WATTS BAR NUCLEAR PLANT (WBN) - NPDES PERMIT NO. TN0020168 - COMPLIANCE
EVALUATION INSPECTION REPORT AND NOTICE OF VIOLATION

ENCLOSURE 1
PLAN FOR CORRECTIVE DRAINAGE UNDER THE
CONCRETE BATCH PLANT AT WATTS BAR NUCLEAR PLANT

ENCLOSURE 2
GENERAL OPERATING INSTRUCTION
FOR THE
SEWAGE TREATMENT FACILITY
AT
WATTS BAR NUCLEAR PLANT

FIGURE 1. WATTS BAR NUCLEAR PLANT – CONCRETE BATCH PLANT DRAINAGE

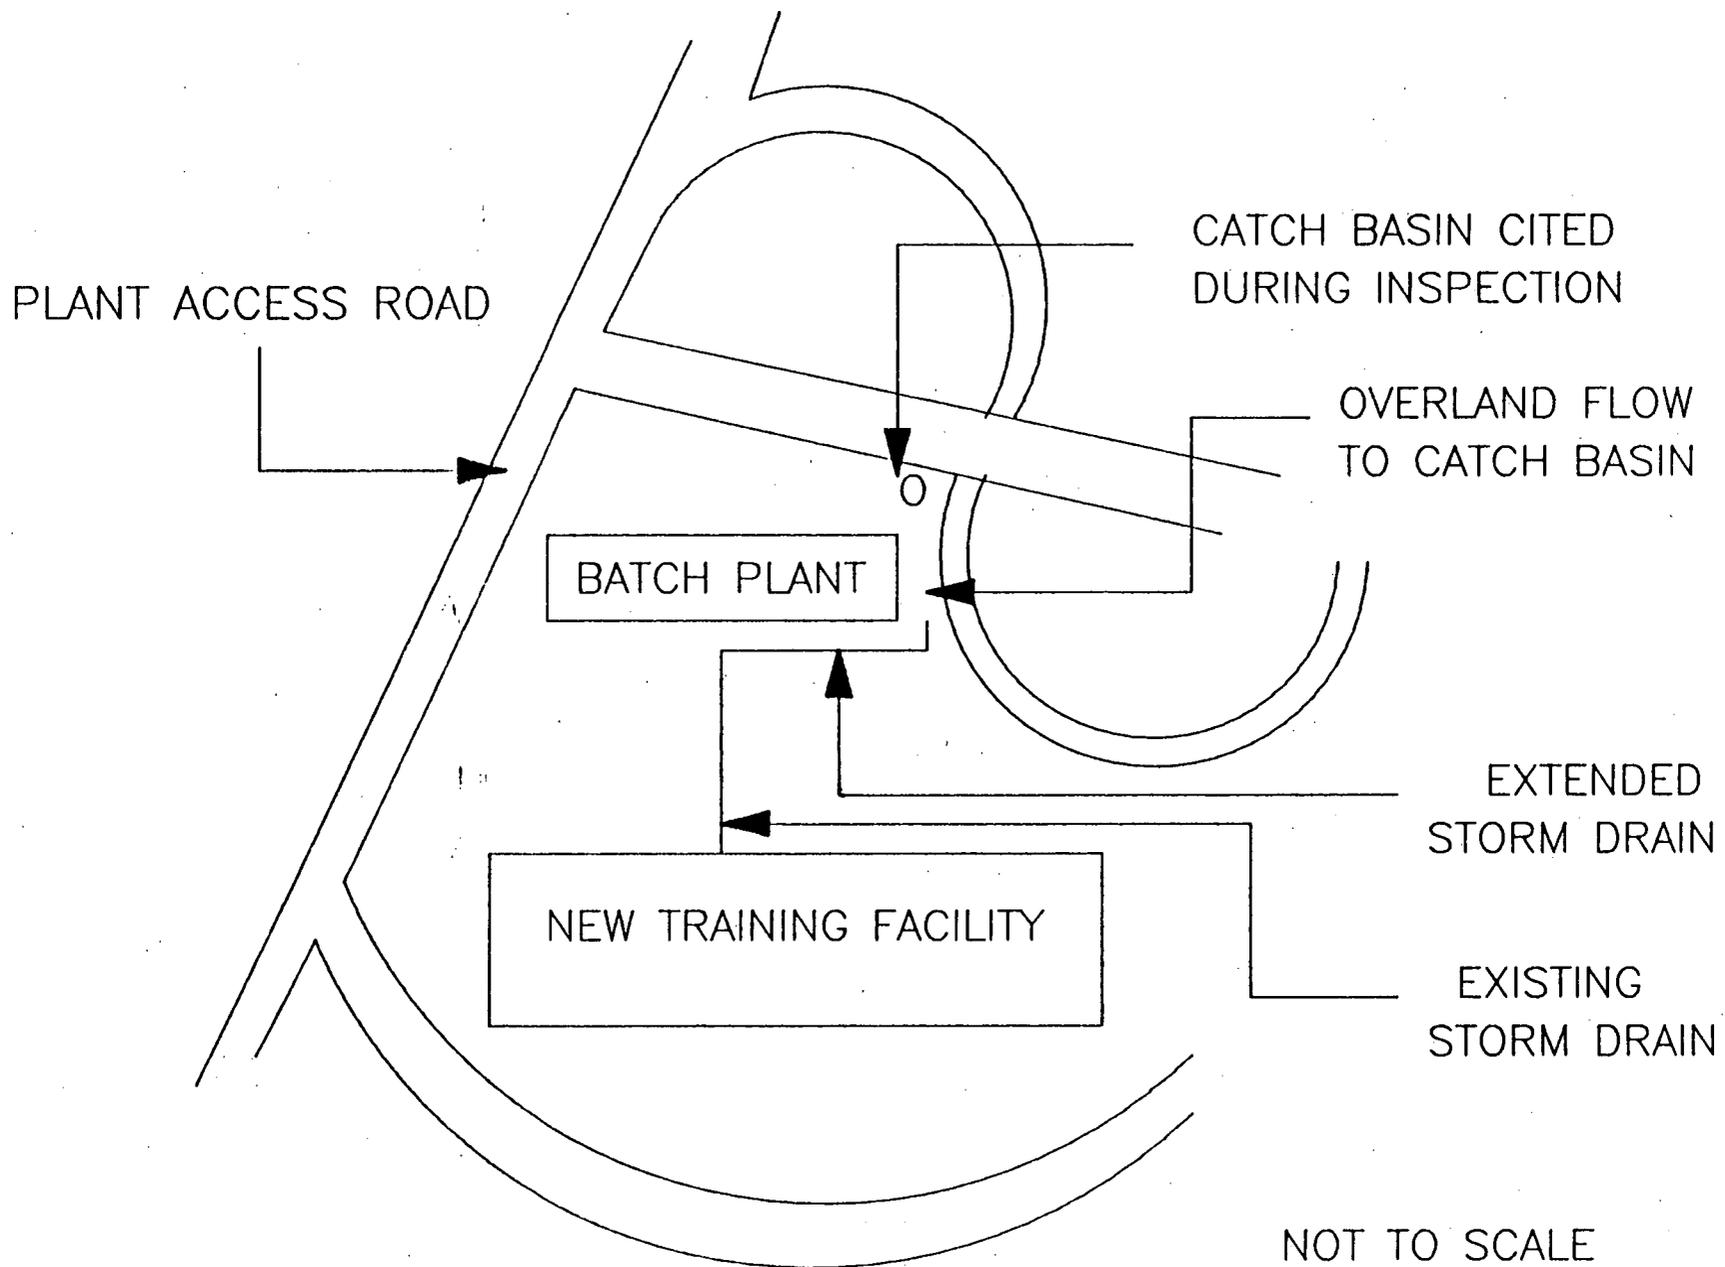
Heavy rainfall created a large flow of water under the loading area of the concrete batch plant and washed cement and fly ash residue down to the catch basin. The major source of the large flow came from a storm drain that serves the new training facility. The storm drain ended such that the water flowed directly under the concrete batch plant on its way to the catch basin cited during the inspection (see figure 1). The storm drain was extended around the batch plant on August 14. The storm drain extension will remain in place until the concrete batch is dismantled and removed. Rock cover and straw bales will be maintained around the catch basin to prevent excessive solids from washing into the basin.
